FL FLL KYAKS TWO (RNAV) STAR

4-28-2022 PRB Results: Returned for Rework

Procedure Review Board (PRB) Results
Florida Metroplex
March 16, 2022

1. **Approval Request:** FORT LAUDERDALE/HOLLYWOOD INTL, FORT LAUDERDALE, FLORIDA (FLL) - KYAKS TWO (RNAV) STAR, <https://swims.faa.gov/Procedure/Edit/7395>

Subject: Leg Length Approval Request: KYAKS RNAV STAR, KFLI

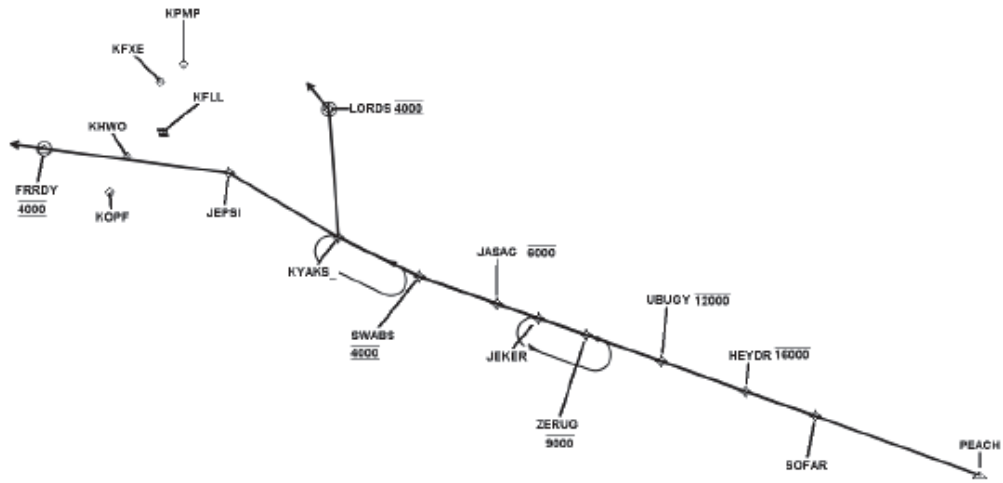
RSO200: [Approval Required] the length of the leg from UBUGY to ZERUG is 11.98 NM. This leg must be at least 15.09 NM long due to deceleration from 310.0 KIAS to 250 KIAS required due to crossing below 10,000 feet MSL.

Using TARGETS Reference software, applying AOB 250K, aircraft pass within current published constraints at ZERUG and all subsequent points with a descent gradient within maximum permissible criteria.

KYAKS ONE ARRIVAL (RNAV) Arrival Routes

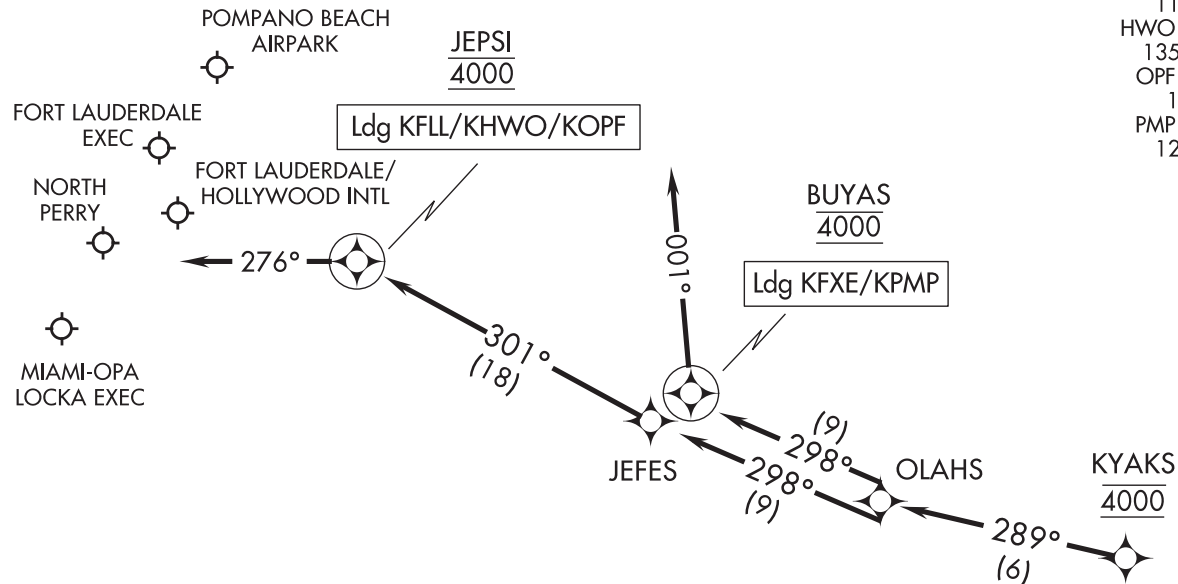
A.IAW 8260.3, PARA 2-2-2C: THE LANDING KFXE/KPMP ARRIVAL ROUTE DESCRIPTIONS DO NOT MATCH WHAT WAS EVALUATED. MULTIPLE HEADINGS ARE NOT ALLOWED. CHANGE 8260-17.1 ARRIVAL ROUTE DESCRIPTION: LANDING KFXE/KPMP: "... THEN ON HEADING 320.00."

2. IAW 8260.3, PARA 2-2-2C: THE LANDING KFXE/KPMP ARRIVAL ROUTE DESCRIPTIONS DO NOT MATCH WHAT WAS EVALUATED. MULTIPLE HEADINGS ARE NOT ALLOWED. CHANGE 8260-17.1 ARRIVAL ROUTE DESCRIPTION:

- IAW 8260.3, PARA 2-2-2C: THE LANDING KFXE/KPMP ARRIVAL ROUTE DESCRIPTIONS DO NOT MATCH WHAT WAS EVALUATED. MULTIPLE HEADINGS ARE NOT ALLOWED. CHANGE 8260-17.1 ARRIVAL ROUTE DESCRIPTION:

A LANDING KFXE/KPMP: "... THEN ON HEADING 320.00."

[Expect a NOTAM on 05-19-2022. Beyond charting cutoff Unable to make change for 05-19-2022](#)

A. LANDING KFXE/KPMP: "... THEN ON HEADING 320.00."

RESPONSE: Updated per PRB recommendation. COMPLETED
